INDEX SHEET FOR SOURCE MATERIAL LICENSE AMENDMENTS OR REVISIONS

Page 1 of 6
Date: 8-13-2008
Docket No. 040-09067
LICENSE NO.: _____

MINE COMPANY NAME: Uranerz Energy Corporation
MINE NAME: Nichols Ranch ISR Project

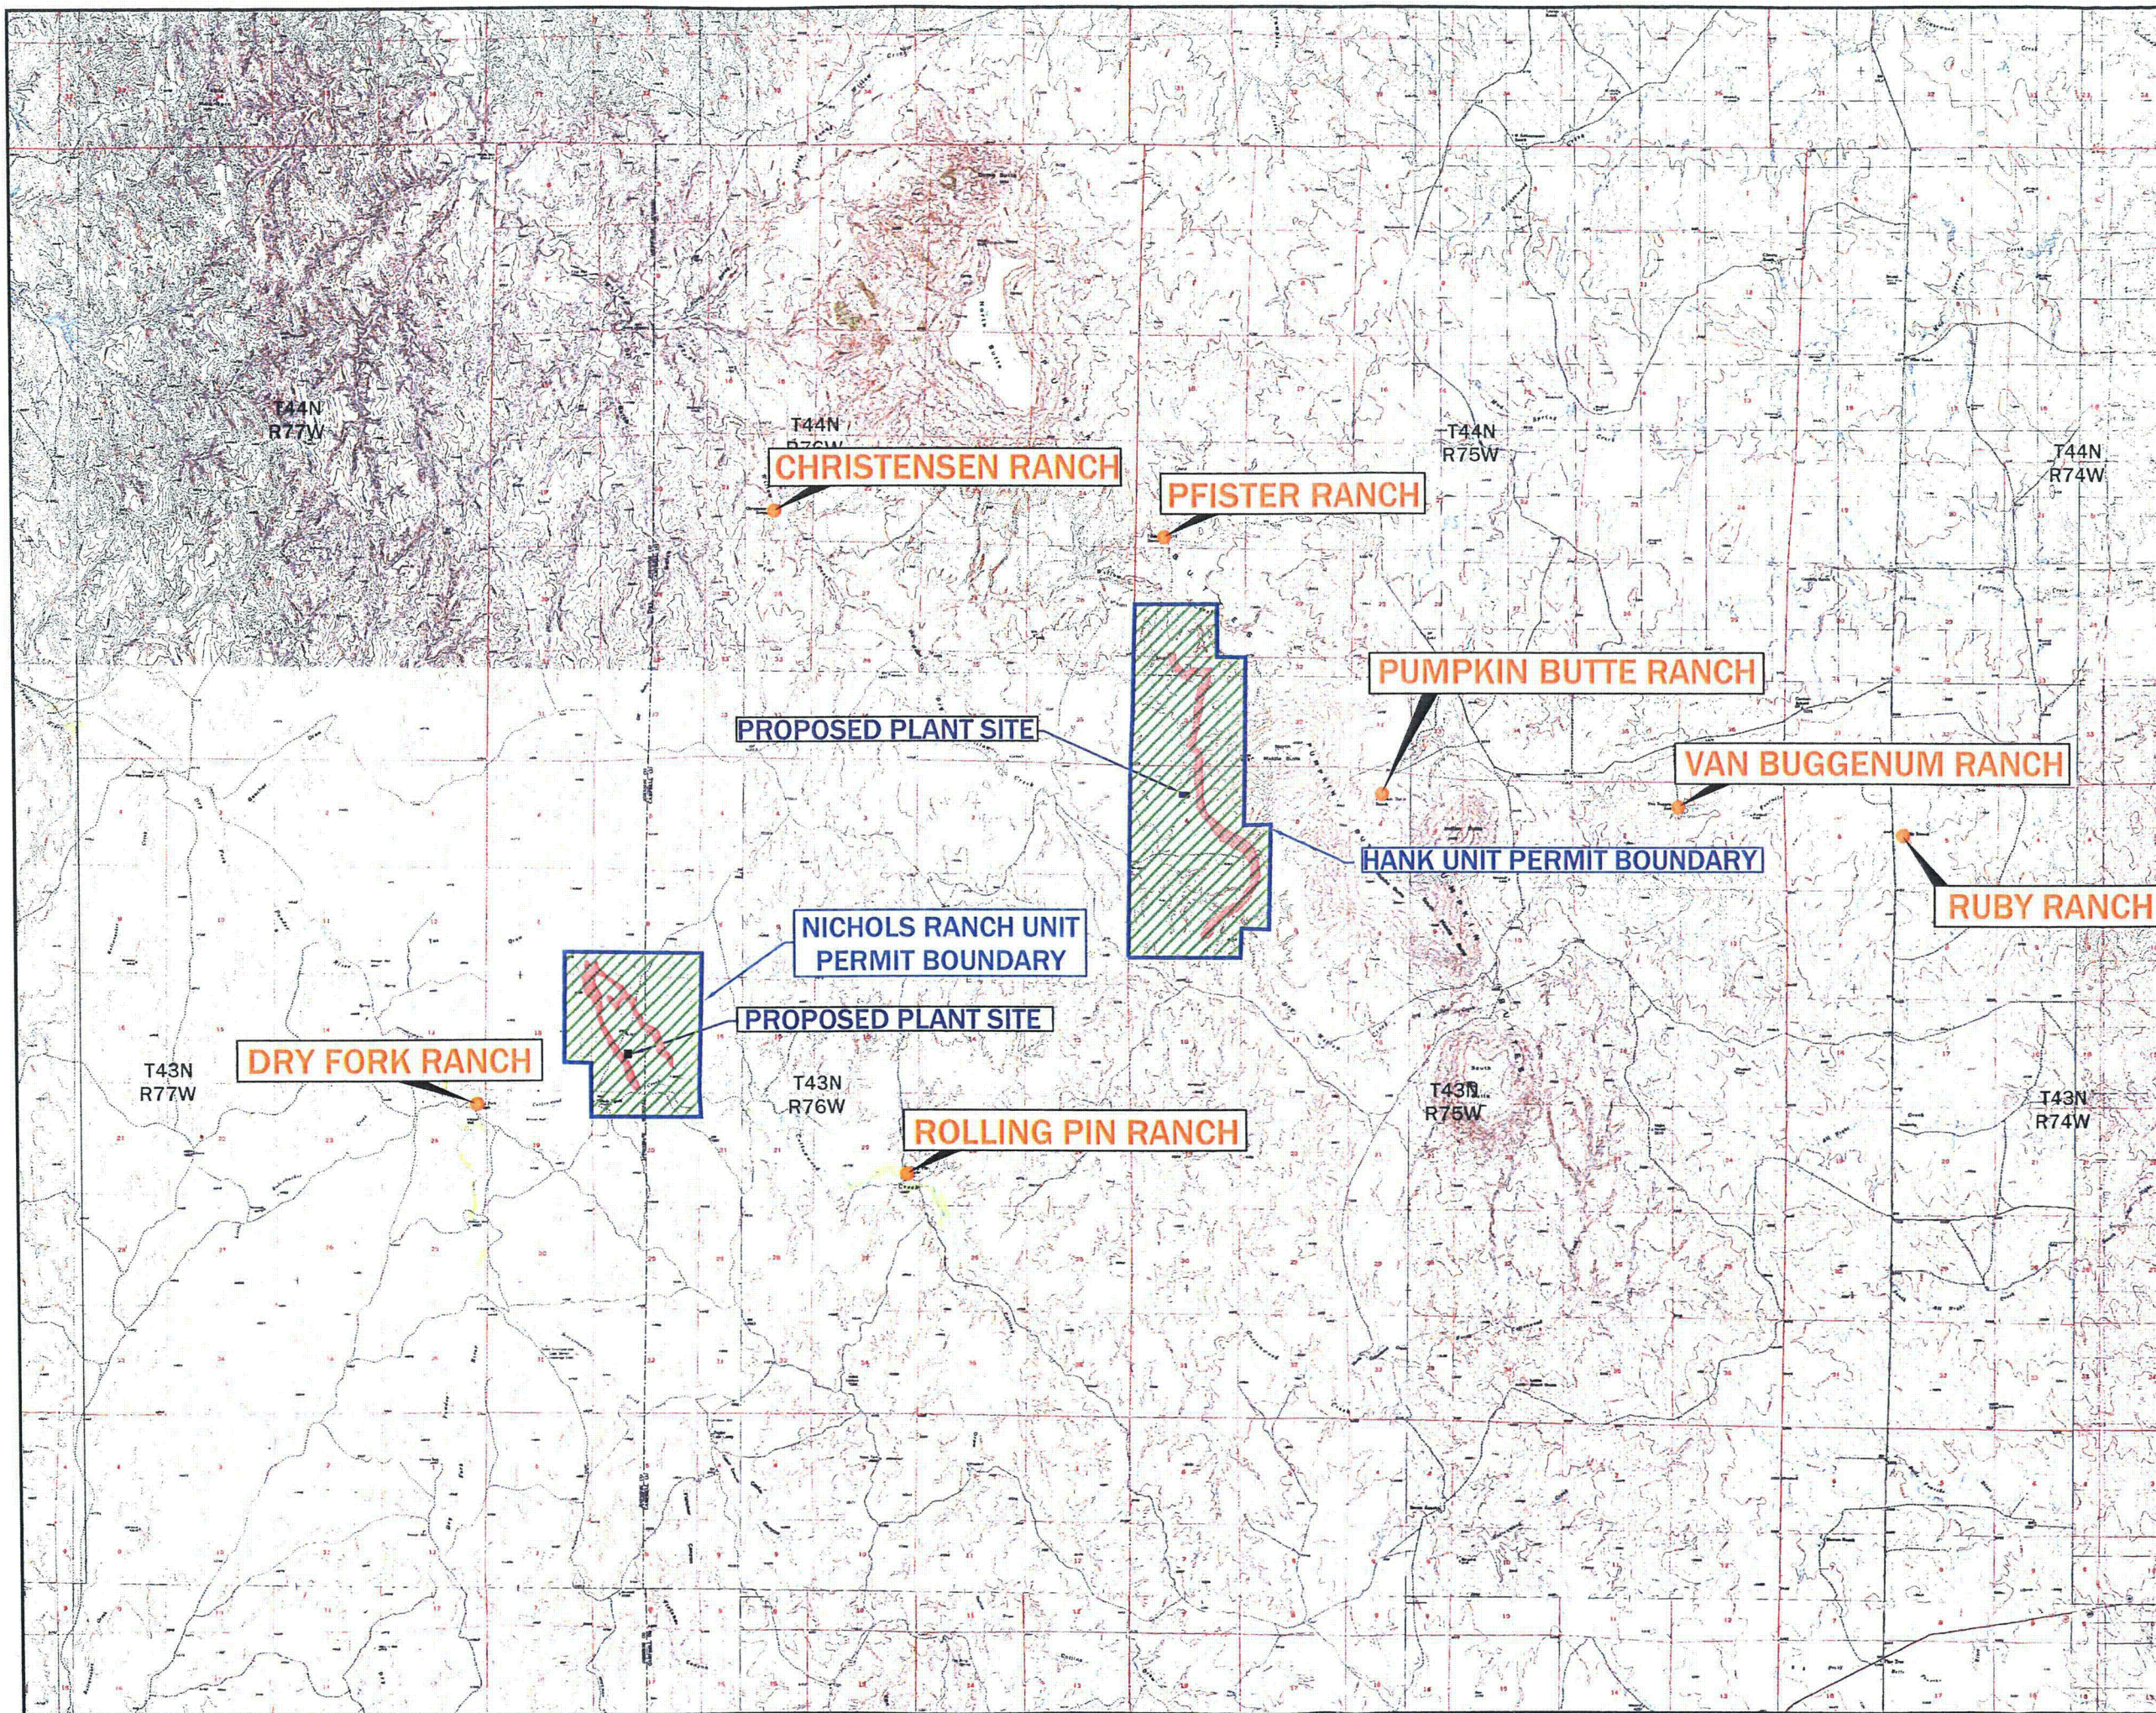
<u>IV, Appendix D1</u>	<u>Pages D1-3 and D1-4</u>	<u>Pages D1-3 and D1-4, March 08</u>	<u>Pages revised to include Figure D1-1 and some minor text changes</u>
<u>IV, Appendix D1</u>	<u>Figure D1-2, Map Pocket</u>	<u>Figure D1-2, March 08 (Map Pocket)</u>	<u>Replaced figure and revised to include past and current land use.</u>
<u> </u>	<u> </u>	<u> </u>	<u> </u>
<u> </u>	<u> </u>	<u> </u>	<u> </u>
<u> </u>	<u> </u>	<u> </u>	<u> </u>
